# Trees and Construction

## BS5837 Method Statement

**Ref:** 13981.21/A1\_AMS Addendum

**1. Addendum Note to Planning Approval 2017/1006/P**

(Mail) 2nd Floor, 1 Hunters Walk, Chester, CH1 4EB Telephone: 0333 123 7080 www.indigosurveys.co.uk	
Drawing Number	A2
13891/TPP/01	REV. B

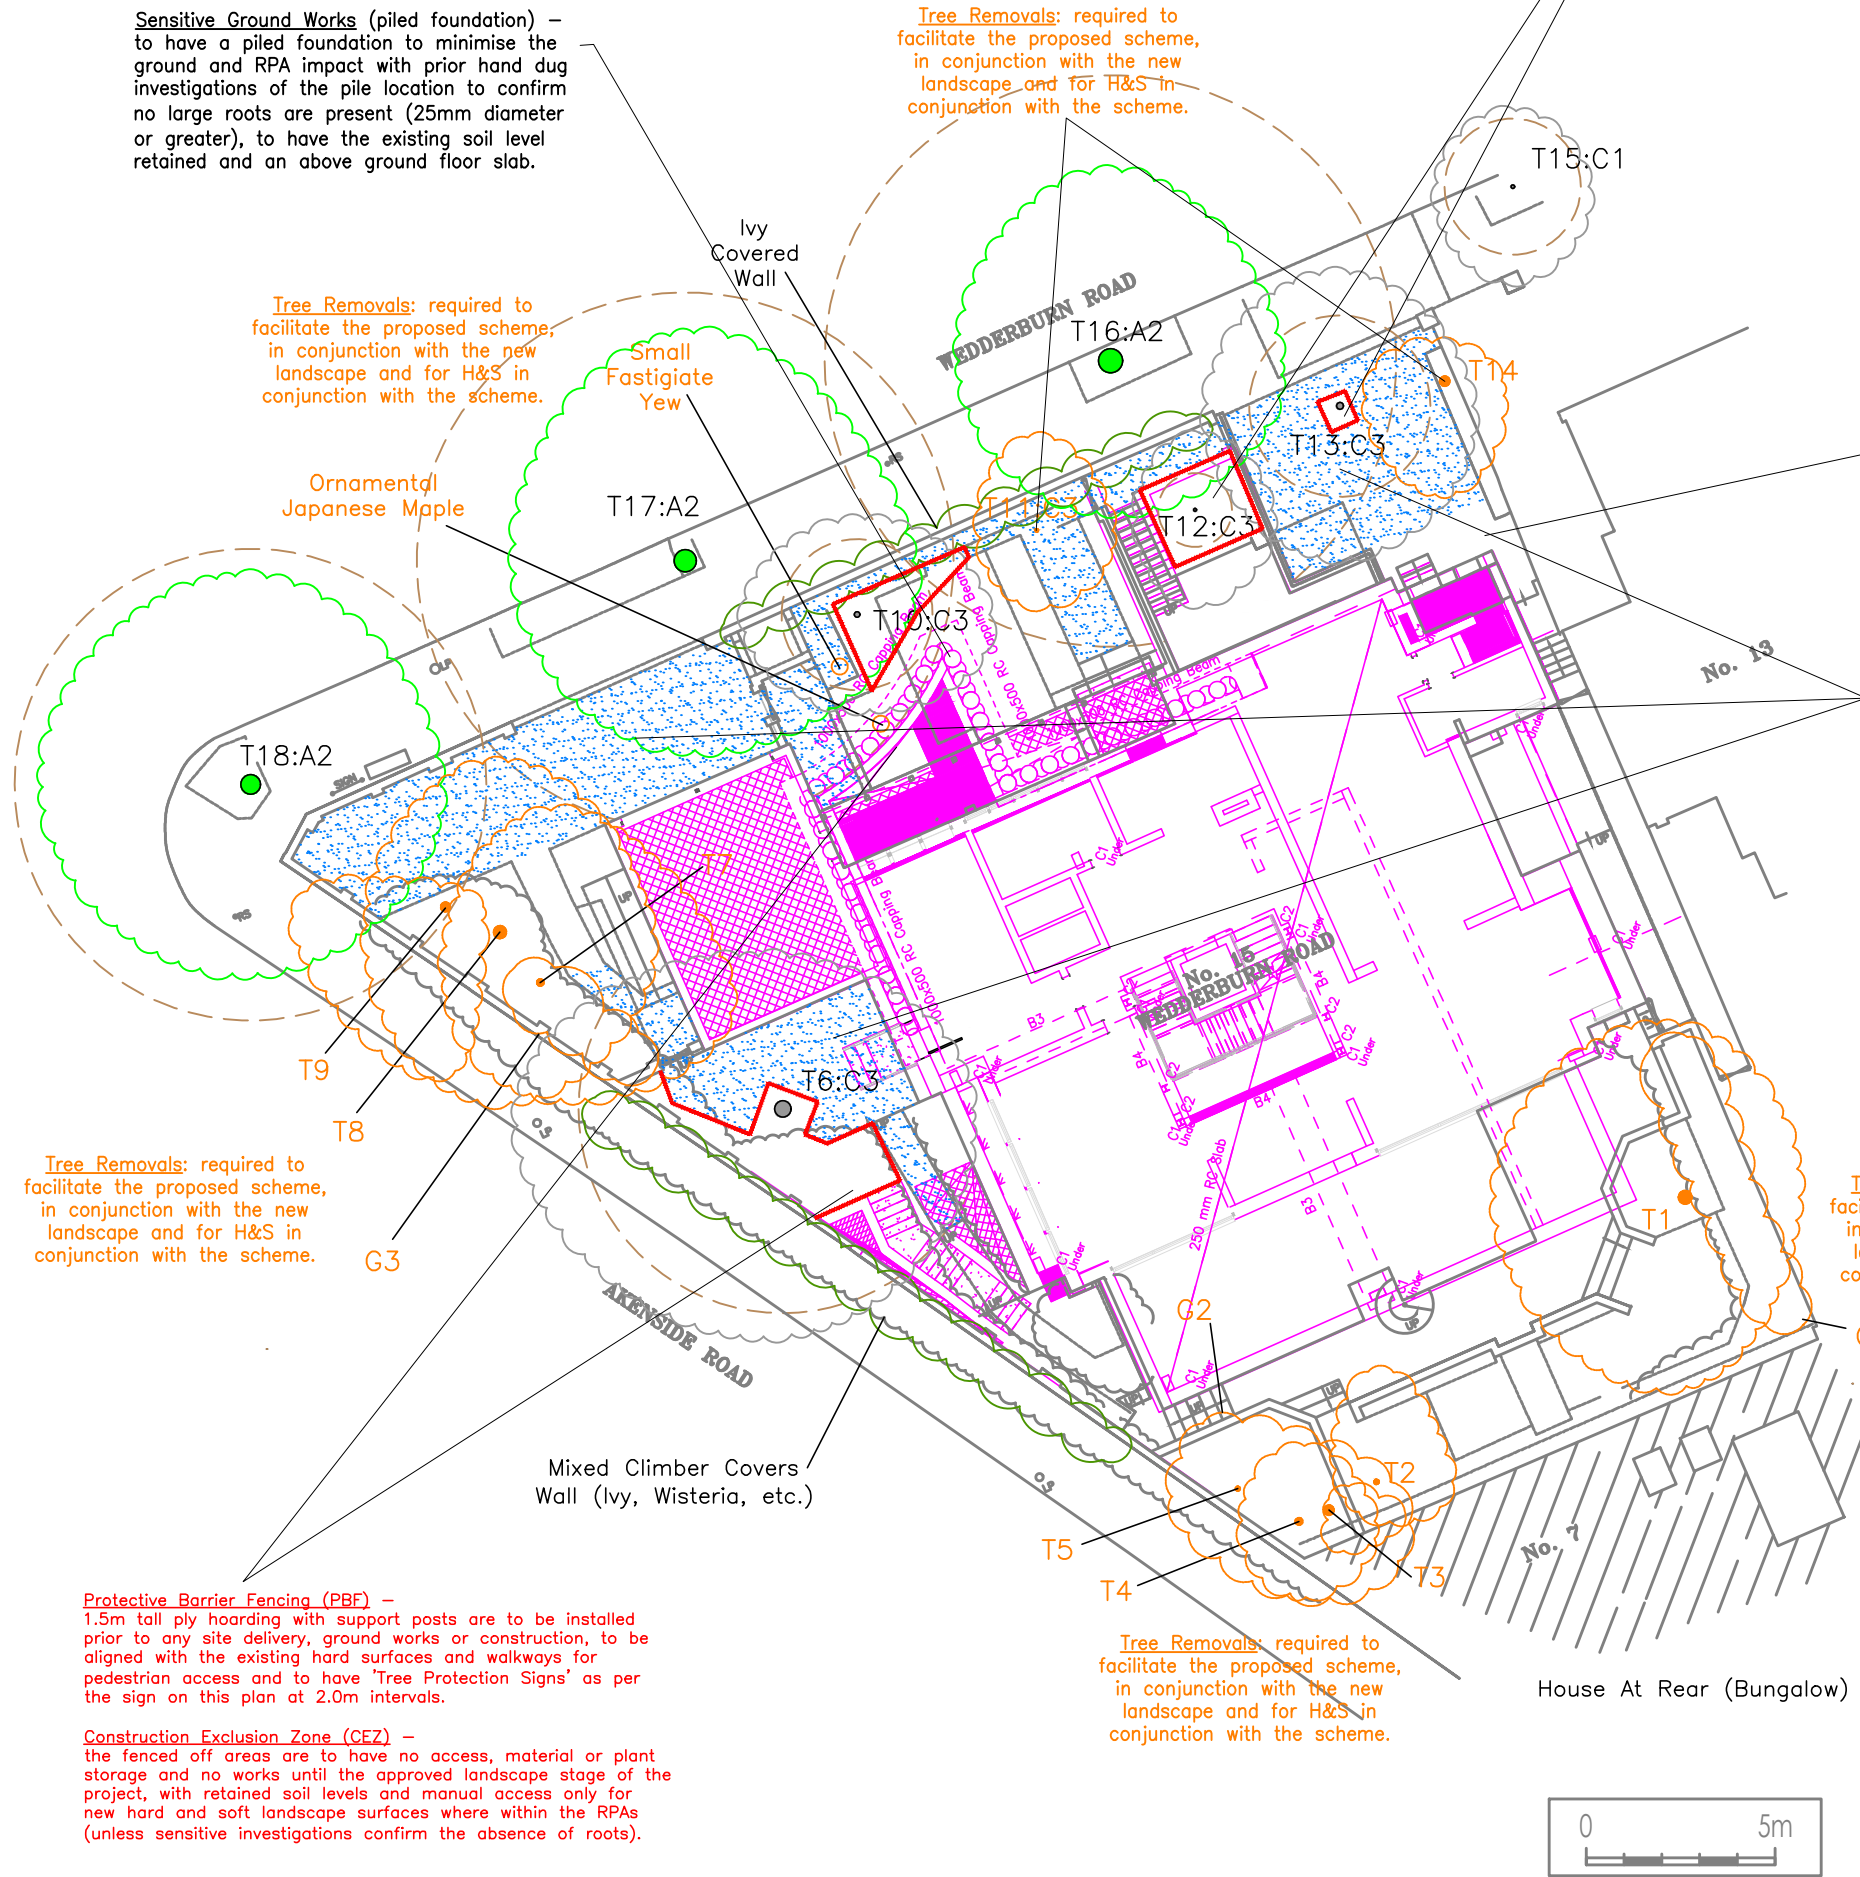
- 1.3 The current approved Tree Protection Plan (TPP) within the 17238/A2\_AIA\_Rev.A (AIA) would render the approved basement unimplementable. The document 13981.21/A1\_AMS (attached) shows a new relevant tree protection measures in the form of an amended TPP which is in line with the approved design

- 1.4 The principles of tree protection within the document ref 17238/A2\_AIA\_Rev.A are to remain but document 13981.21/A1\_AMS (attached) updates the Tree Protection Plan (TPP) and site-specific methods. This is in the light of the drawing 201\_P2 which is listed as approved. Drawing 201\_P2 shows the intended agreed line of the proposed sub-basement to the proposal which the new TPP addresses.

Protective Barrier Fencing (PBF) – 1.5m tall ply hoarding with support posts are to be installed prior to any site delivery, ground works or construction, to be aligned with the existing hard surfaces and walkways for pedestrian access and to have 'Tree Protection Signs' as per the sign on this plan at 2.0m intervals.

Construction Exclusion Zone (CEZ) – the fenced off areas are to have no access, material or plant storage and no works until the approved landscape stage of the project, with retained soil levels and manual access only for new hard and soft landscape surfaces where within the RPAs (unless sensitive investigations confirm the absence of roots).

- Sensitive Hard Landscape Works (PBF) –
- The existing hard surfaces and access routes are retained within RPAs during building works;
  - Soft surfaces within RPAs are to have post and rope / chestnut pale fences installed prior to any site delivery, ground works or construction, to be aligned with the existing hard surfaces and walkways for pedestrian access and to have 'Tree Protection Signs' as per the sign on this plan at 2.0m intervals; and
  - Hard landscape works are to be undertaken after building works, to remove the existing hard landscape manually and sensitively down to the existing soil level only, with new hard landscape to be laid manually atop the existing soil level and be permeable.
